Reliability Analysis Update

Transmission Expansion Advisory Committee
December 1, 2020

AEP Transmission Zone B2779 Scope/Cost change

Scope/Cost change for B2779.1 -.5

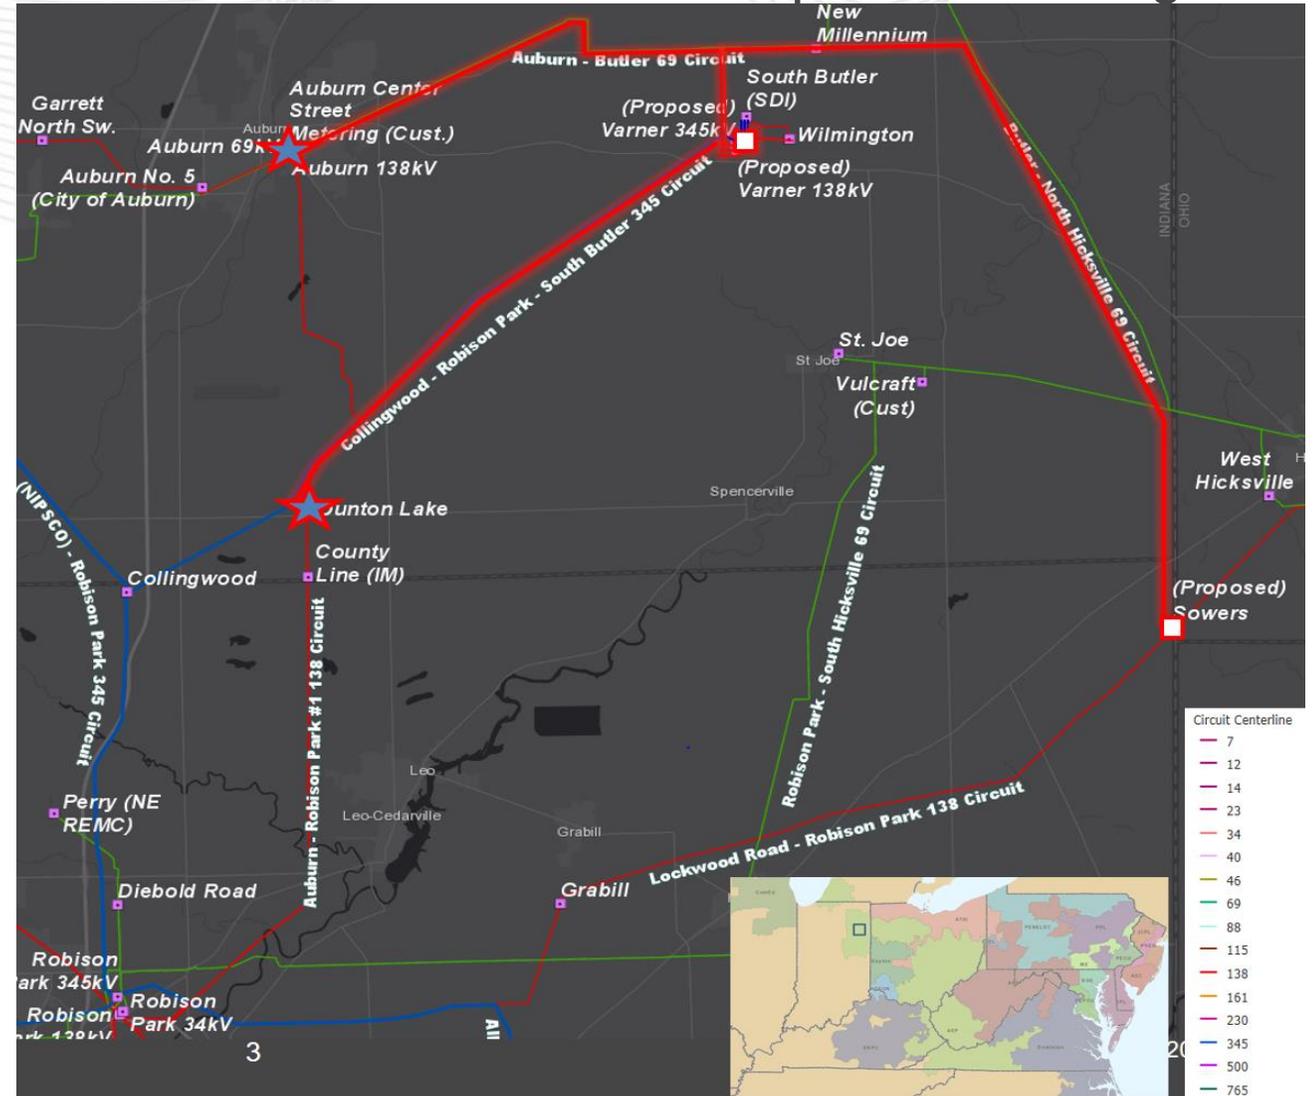
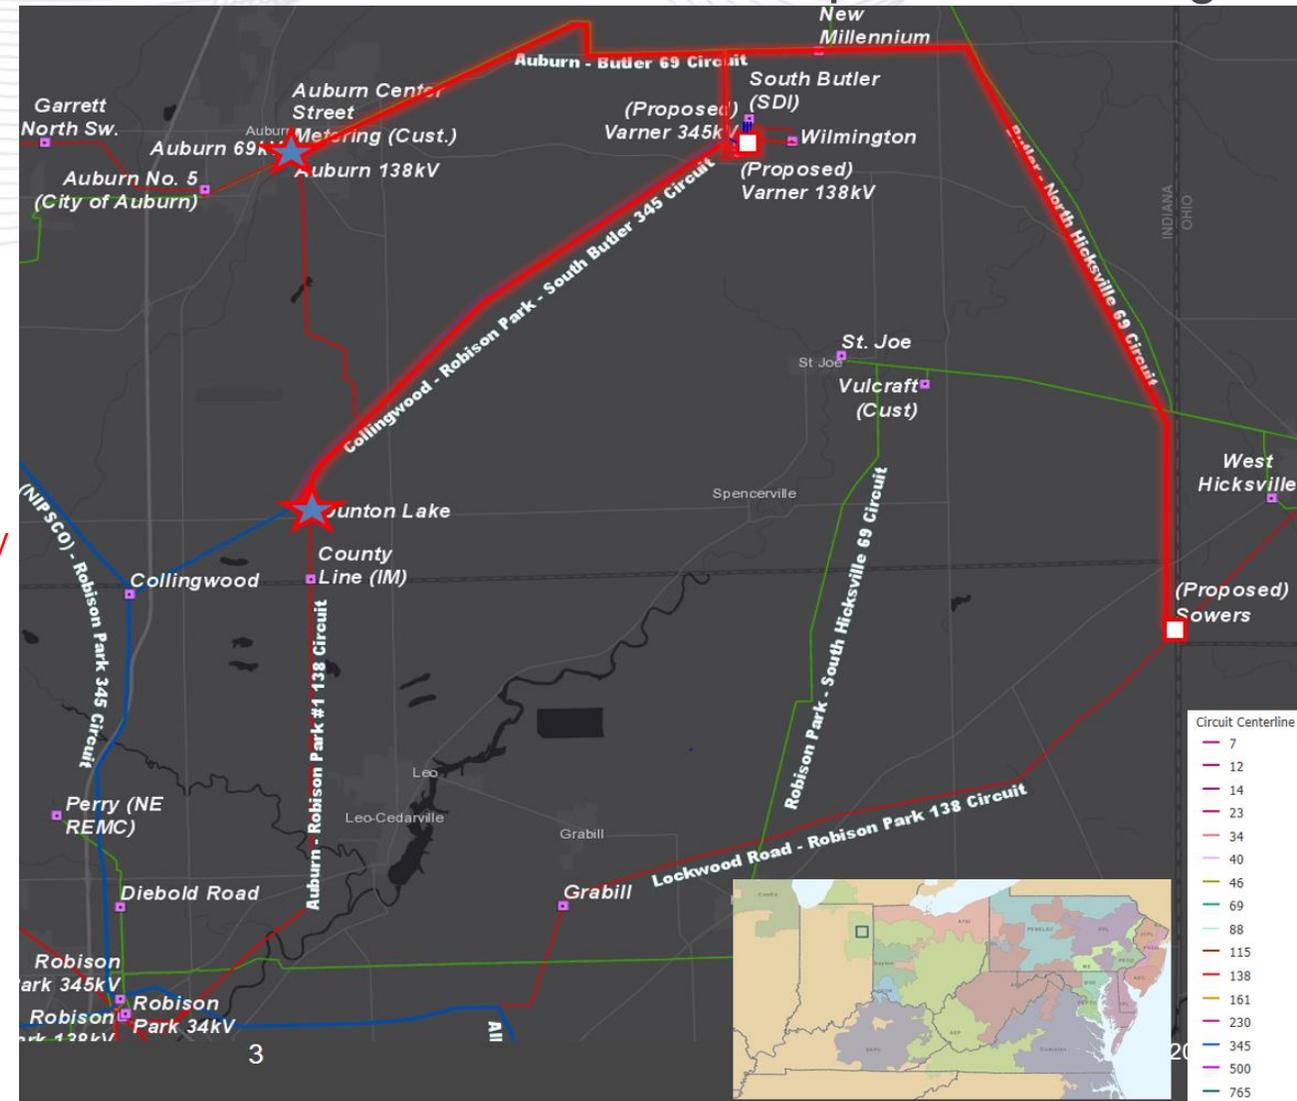
Original Project Scope: (Previous presented on 1/12/2017 TEAC)

- Construct a new 138 kV station, Sowers (Originally named Campbell Road), tapping into the Grabill – South Hicksville 138kV line (**B2779.1**)
- Reconstruct sections of the Butler-N.Hicksville and Auburn-Butler 69kV circuits as 138kV double circuit and extend 138kV from Sowers station (**B2779.2**)
- Construct a new 345/138kV SDI Varner (Originally named Willington) Station which will be sourced from Collingwood 345kV and serve the SDI load at 345kV and 138 kV respectively (**B2779.3**)
- 138kV circuits will be looped in-out of the new SDI Varner station resulting in a direct circuit to Auburn and Rob Park via Dunton Lake, and a circuit to Sowers; Reconductor 138kV line section between Dunton Lake – SDI Wilmington (**B2779.4**)
- Expand 138kV bus at Auburn (**B2779.5**)

Major Cost Drivers:

- Varner & South Butler cost increase due to circuit breaker additions to ensure segregation of customer and AEP facilities in accordance with AEP connection requirements*: \$6.7 M
- Flicker reduction for local customers requiring an expanded 345kV yard with reactors and capacitor banks: \$20.3 M
- Collingwood cost increase due to security enhancements and space constraints: \$14M
- Cost increase from functional to detail scope: \$6.9M
- Wilmington Tap relocation work**: \$2.4M
- Cost of (3) 345kV feeds from Varner to South Butler: \$6M

- *AEP's interconnection requirements require a circuit breaker at the customer end for lines longer than 2 spans. Additional 345kV CB's at South Butler station are required due to supplying three feeds to the load. This configuration also would have required AEP to purchase the through path at South Butler station.
- **To accommodate (3) 345kV lines from Varner to South Butler, the Wilmington Tap had to be rerouted and rebuilt.

- The proposed construction plan would require a prolonged outage of the Collingwood 345kV line, which is the only line that currently serves 300+ MW demand at SDI.
- SDI cannot afford to take a prolonged outage.
- The resolution would involve building of the 138 kV infrastructure before the 345 kV outages can be taken resulting in prolonged flicker exposure to local customers.
- Additionally, the future expansion at SDI would risk increased flicker levels to other customers.
- To arrest cost increases and avoid flicker exposure, AEP is recommending modifications to the project scope in consultation with SDI.

New Project Scope:

- Construction a new 138 kV station, Sowers, tapping into the Grabill – South Hicksville 138kV line (**B2779.1**) **Estimated Cost: \$10.1M**
- Reconstruct sections of the Butler-N.Hicksville (9.6miles) and Auburn-Butler (9 miles) 69kV circuits as 138kV double circuit and extend 138kV from Sowers station (3.5miles); (**B2779.2**) **Estimated Cost: \$45.1M**

- Construct a new 345/138kV SDI Varner Station which will ~~be sourced from Collingwood 345kV and~~ serve a portion of the SDI load from the ~~345kV and~~ 138 kV system; ~~respectively~~ Serve Wilmington Tap from new Varner 138 kV station. Add additional breakers at South Butler station to comply with AEP Interconnection Guidelines. (**B2779.3**) **Estimated Cost: \$37.6M**

- 138kV circuits will be looped in-out of the new SDI Varner station resulting in a direct circuit to to Auburn ~~and Rob Park via Dunton Lake, and a circuit to~~ Sowers and Wilmington. String approximately 3 miles of the open side of circuit between Collingwood and Dunton Lake with new conductor thus establishing a second 345 kV feed (utilizing 9 miles of existing 138 kV feed constructed as 345 kV) (**B2779.4**) **Estimated Cost: \$14.8M**

- Expand 138kV bus at Auburn (**B2779.5**) **Estimated Cost: \$2.6M**
- Construct a 345kV ring bus at Dunton Lake to serve load at SDI at 345 kV via two circuits (**B2779.6**) **Estimated Cost: \$23.4M**

- Retire Collingwood station (**B2779.7**) **Estimated Cost: \$1.4M**

New Total Estimated Total Cost: \$135M

The new configuration splits the load at SDI to serve the furnaces via the 345 kV lines from Dunton Lake and the segregated load via the 138 kV lines from Auburn and Sowers. This configuration eliminates the prolonged outage concerns and also improves power quality by keeping the arc furnaces on the 345 kV. Additionally, the updated configuration allows for future maintenance on any feed to SDI. The total estimated cost is \$29.2M less than the original solution.
